PUBLIC IMPROVEMENT CONSTRUCTION PLANS

DAWSON TRAILS BLVD (NORTH)

LOCATED IN SECTION 15, TOWNSHIP 8 SOUTH, RANGE 67 WEST, THE SOUTHEAST $\frac{1}{4}$ CORNER OF SECTION 10, TOWNSHIP 8 SOUTH, RANGE 67 WEST OF THE 6TH PRINCIPAL MERIDIAN, TOWN OF CASTLE ROCK, COUNTY OF DOUGLAS, STATE OF COLORADO.
TOWN OF CASTLE ROCK PROJECT NO. CD23-0020

3rd Drainage and
Floodplain Review
David Van Dellen
720.733.2474
dvandellen@crgov.com
7/21/25

COVER

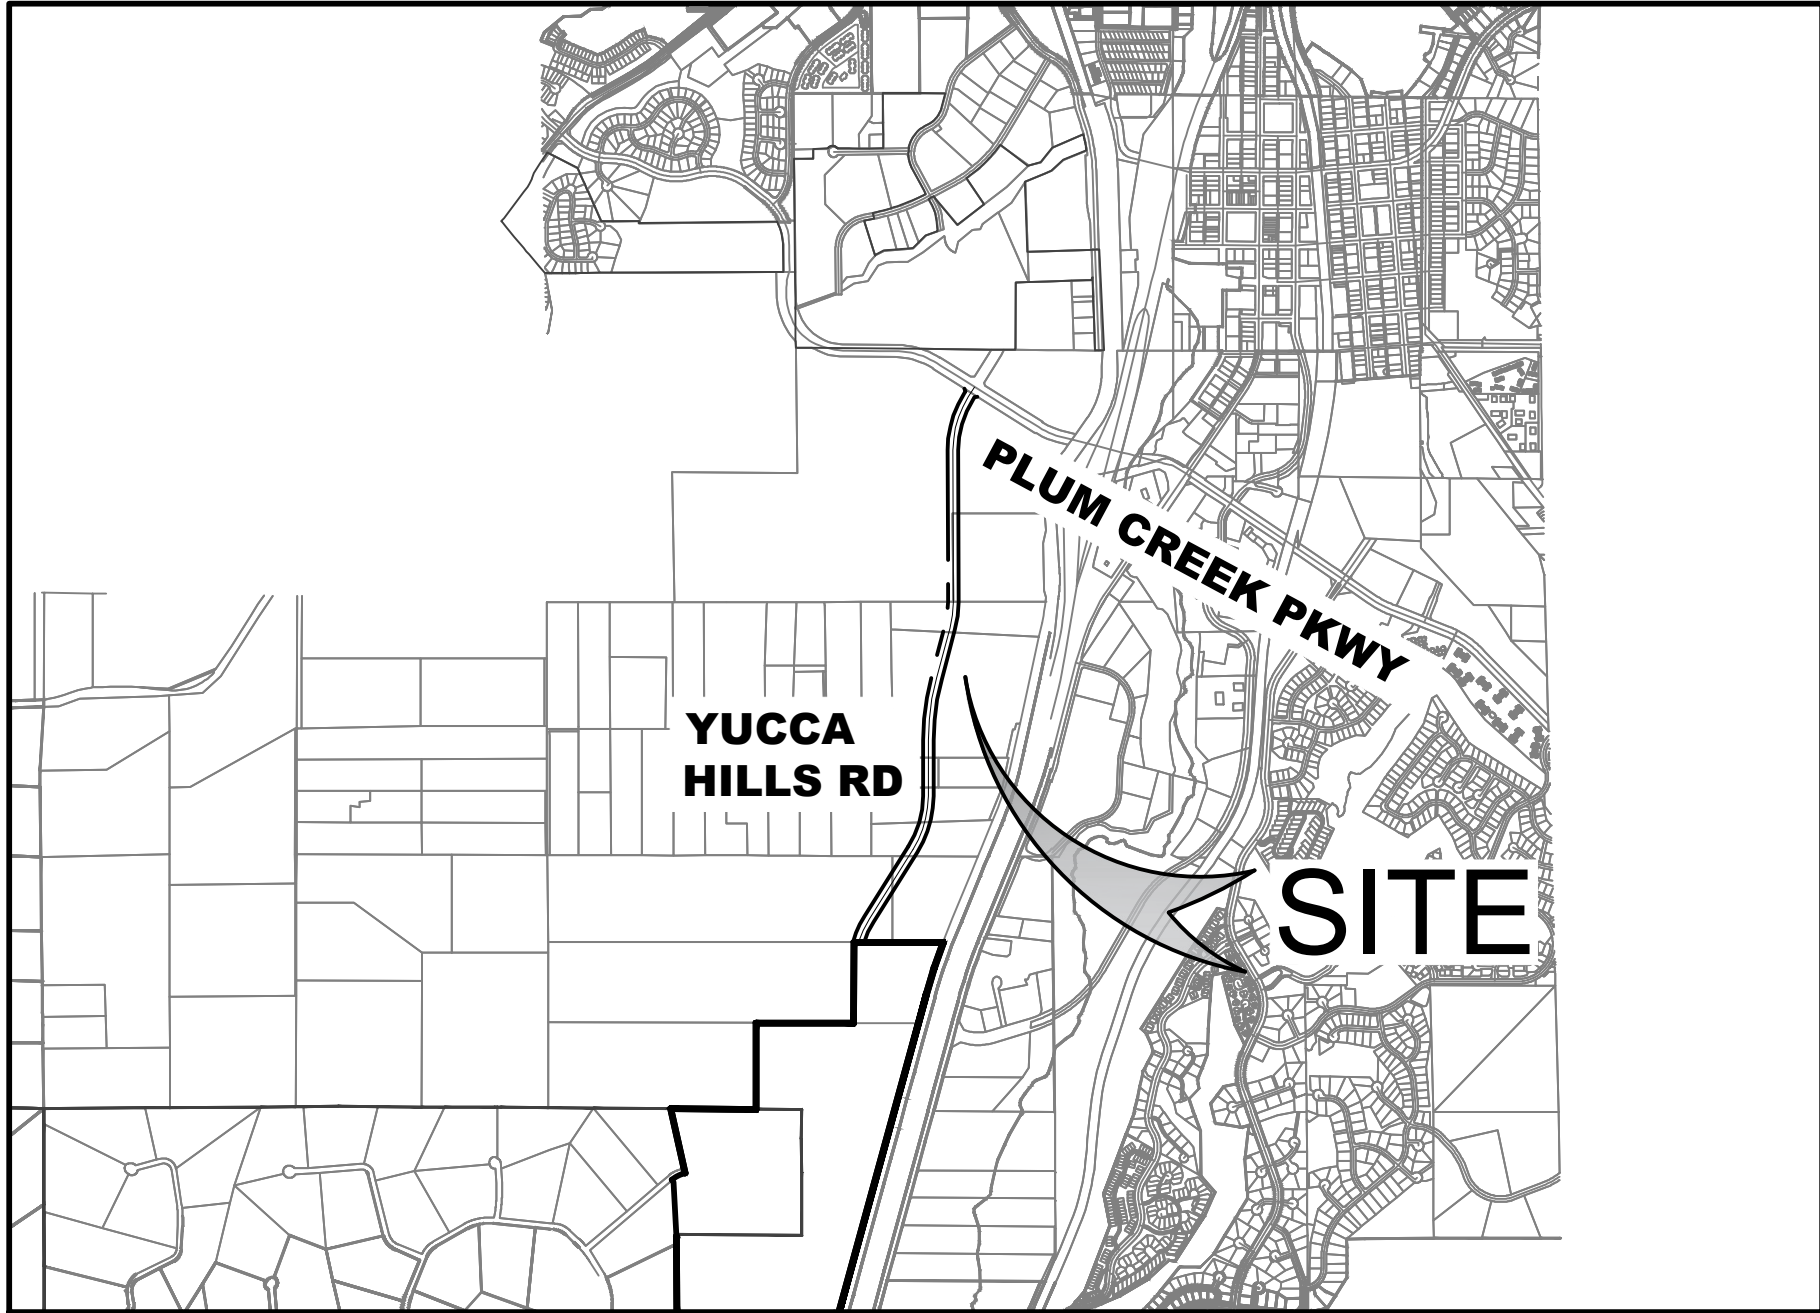
DC - Has all ROW and easements been acquired across parcels within Douglas County Jurisdiction?

DC - Is the Town going to acquire the full East portions of the lots (Core, Nichols, Three Oaks and Burmeister)that are split by Dawson Trails Blvd.? If not how will those lot owners be able to utilize their property once it is divided by Dawson Trails Blvd.?

CORE - ROW and easements have not been acquired at this time across parcels within Douglas County Jurisdiction. Negotiation with land owners is in progress. Acquisition will need to be completed before final approval of construction documents.

CORE - The Town has not indicated they will acquire the full east portions of the lots. Lot owners will access their lots via Dawson Trails Blvd access drives, to be constructed by the lot owners. An "Access Plan" has been added to the Construction Document set, which indicates potential access locations to all lots, to indicate that reasonable access can be obtained by the lot owners.
